TENNESSEE VALLEY AUTHORITY

February 15, 1985

WATTS BAR NUCLEAR PLANT  
RESULTS OF THE REDUCED ICE WEIGHT  
ANALYSIS PERFORMED BY WESTINGHOUSE

FSAR REVISIONS TO REFLECT THE RESULTS OF THE  
REDUCED ICE WEIGHT ANALYSIS

FIGURE 6.2.1-1. PRESSURE VS. TIME

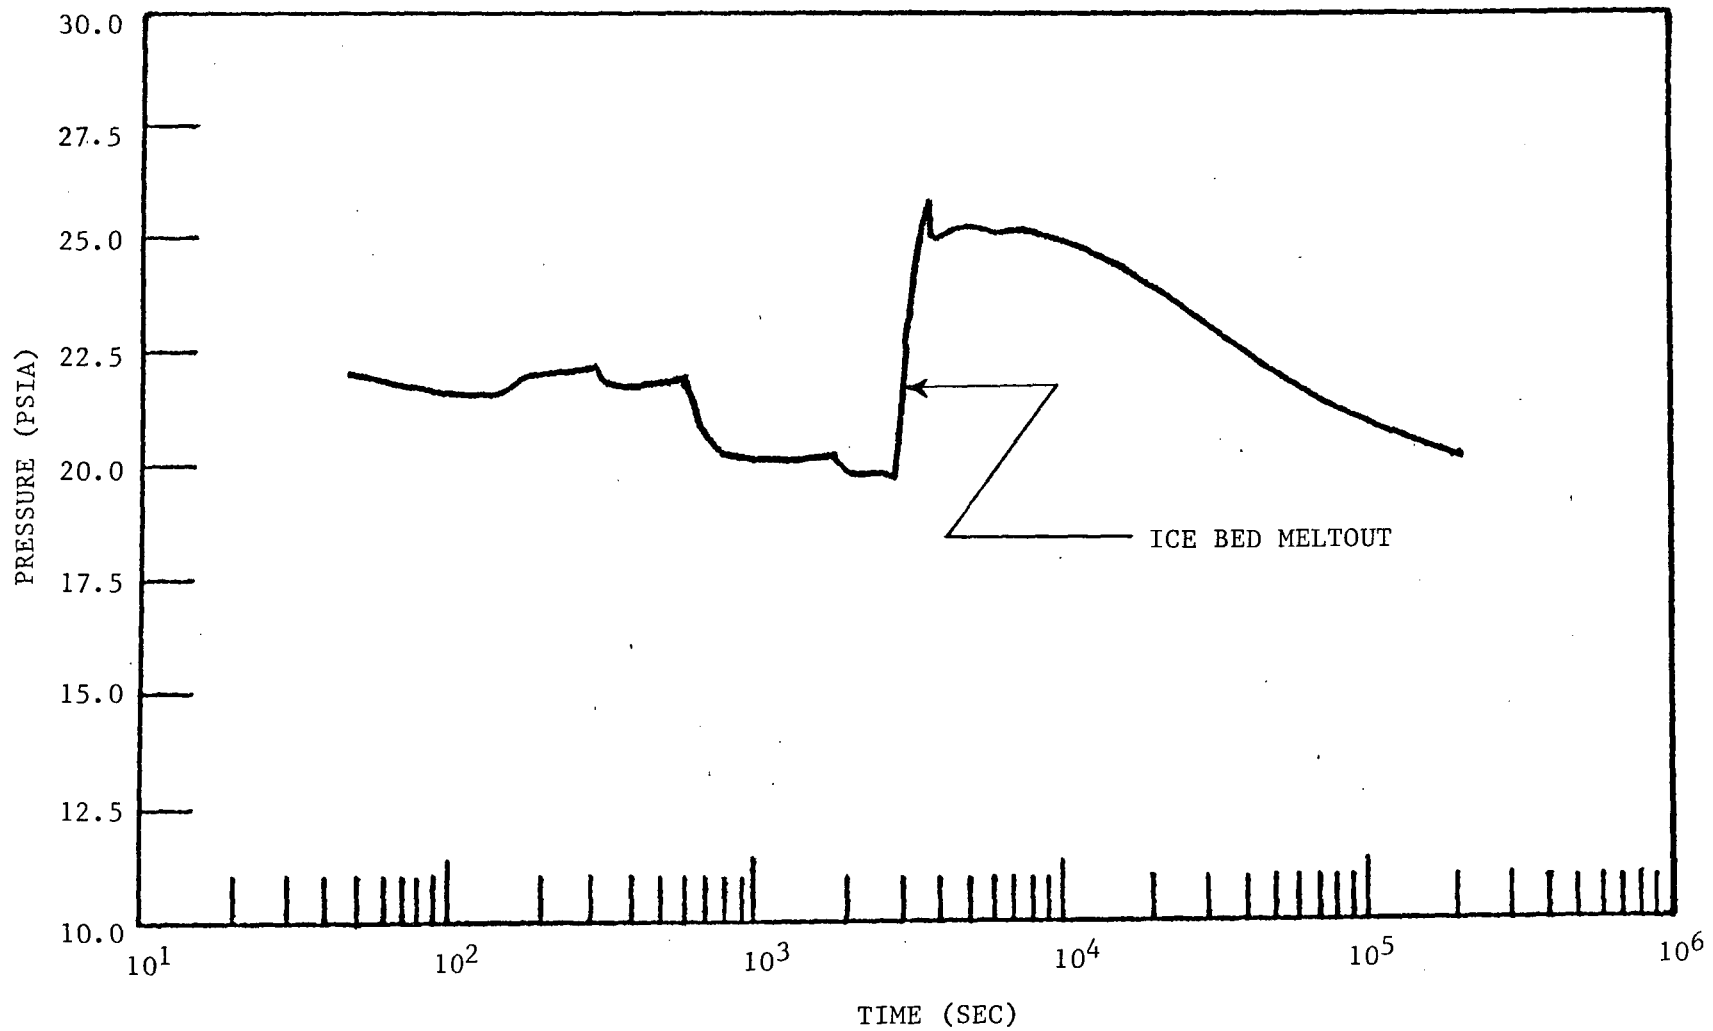
As can be seen from Figure 6.2.1-1 the maximum calculated Containment pressure is <sup>3600.9</sup> ~~12.3~~ psig, occurring at approximately <sup>11.21</sup> ~~7000~~ seconds.

FIGURE 6.2.1-3. ACTIVE AND INACTIVE SUMP TEMPERATURE TRANSIENTS

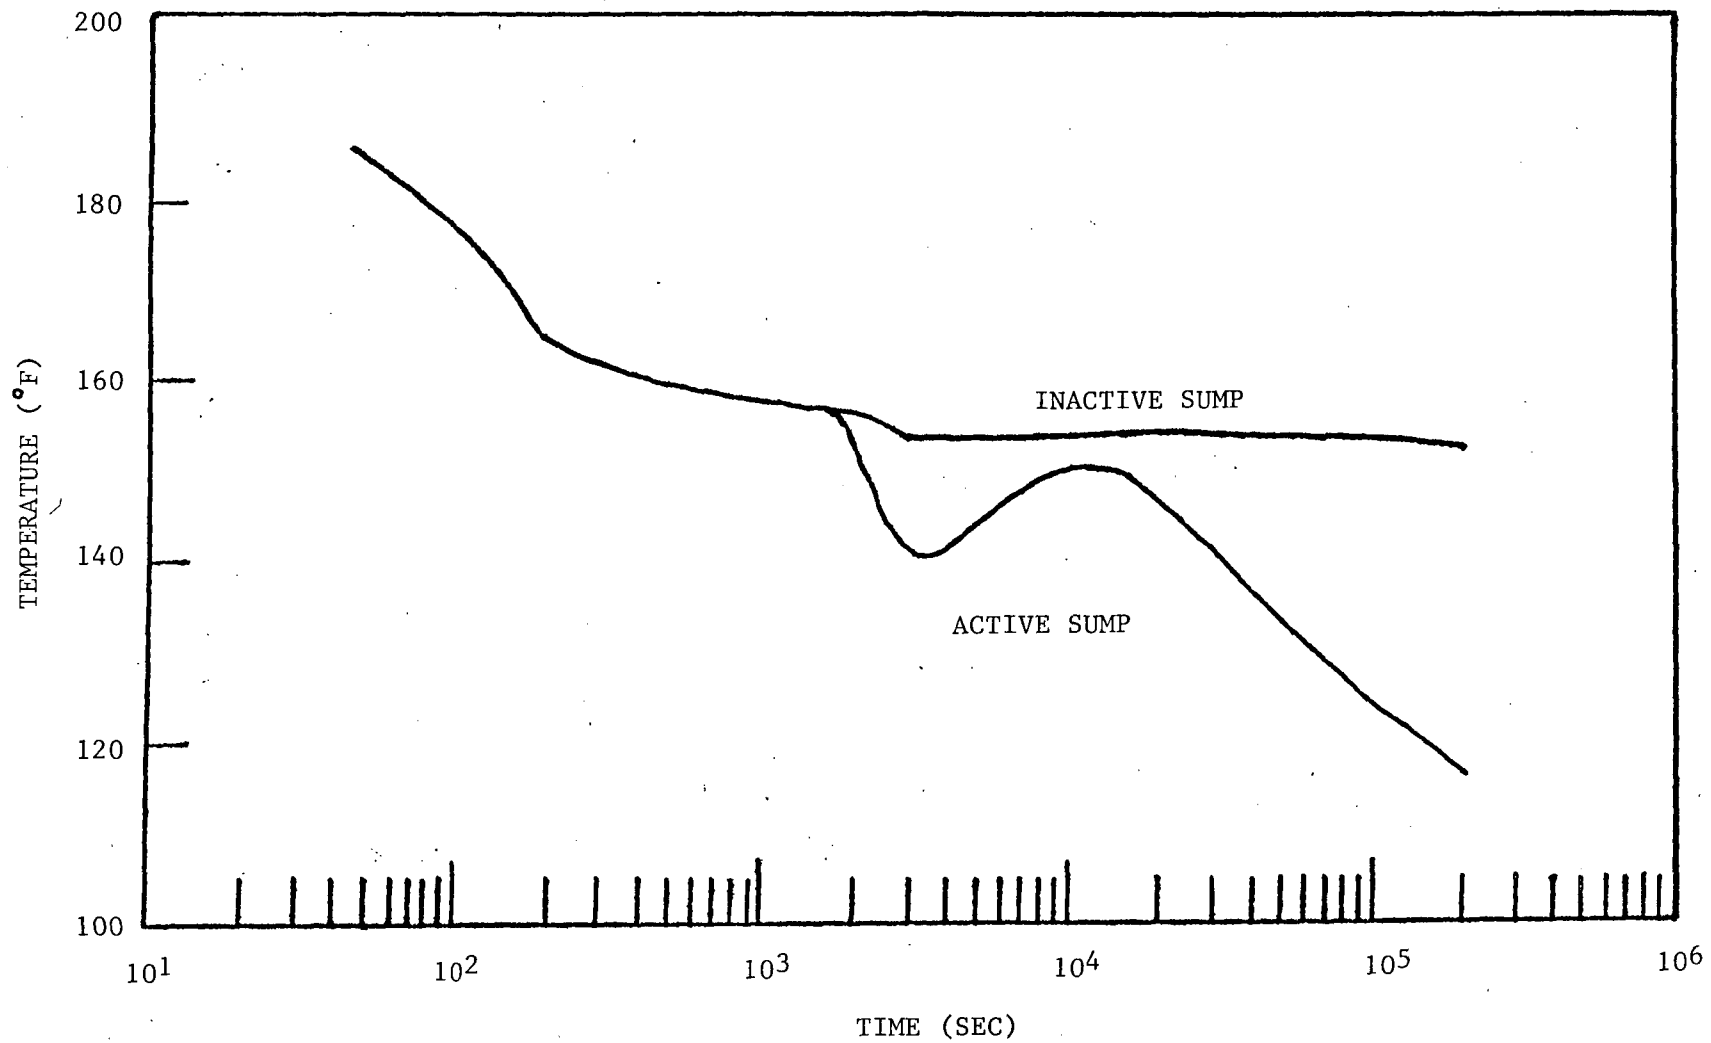
Figure 6.2.1-3, Active <sup>and inactive</sup> sump temperature transient

FIGURE 6.2.1-4. ICE MELT TRANSIENT

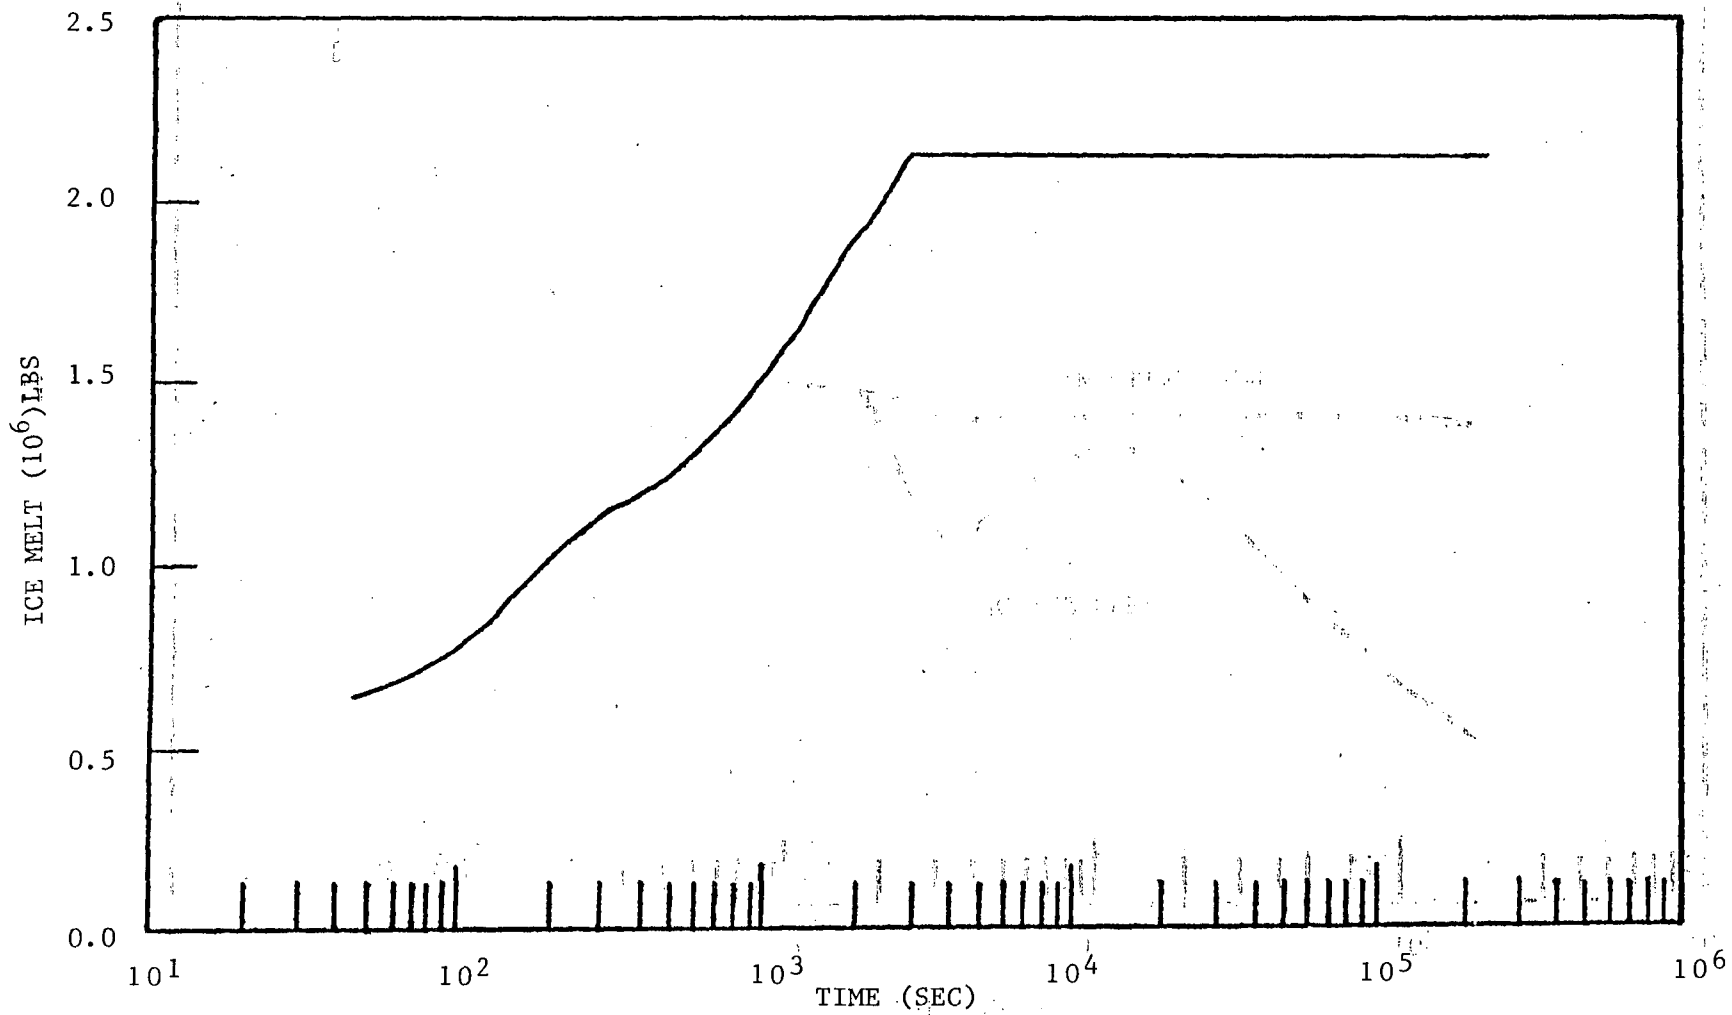
Figure 6.2.1-4, <sup>Ice melt transient</sup> ~~Inactive sump temperature transient~~

FIGURE 6.2.1-4A. ICE MASS VS. PRESSURE

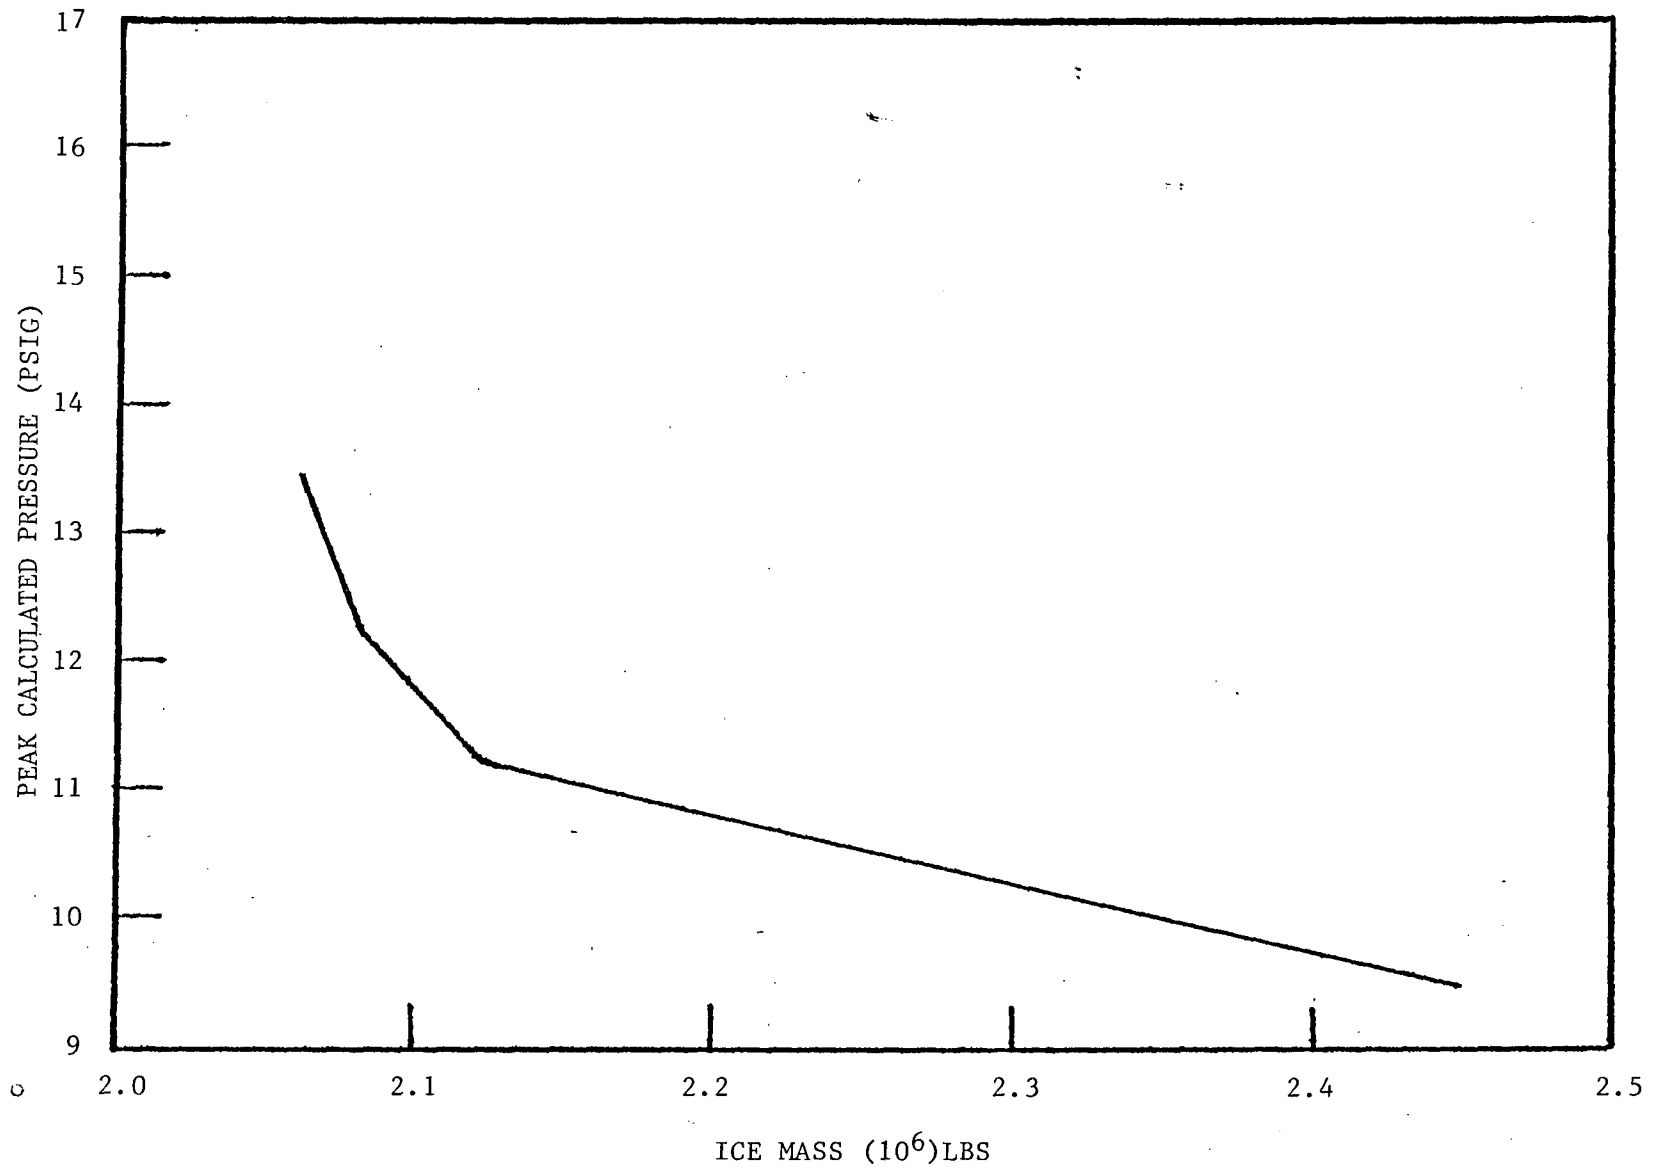
Also, a parameter study of the ice mass was performed. These results Structural Heat Removal are presented in Figure 6.2.1-4A
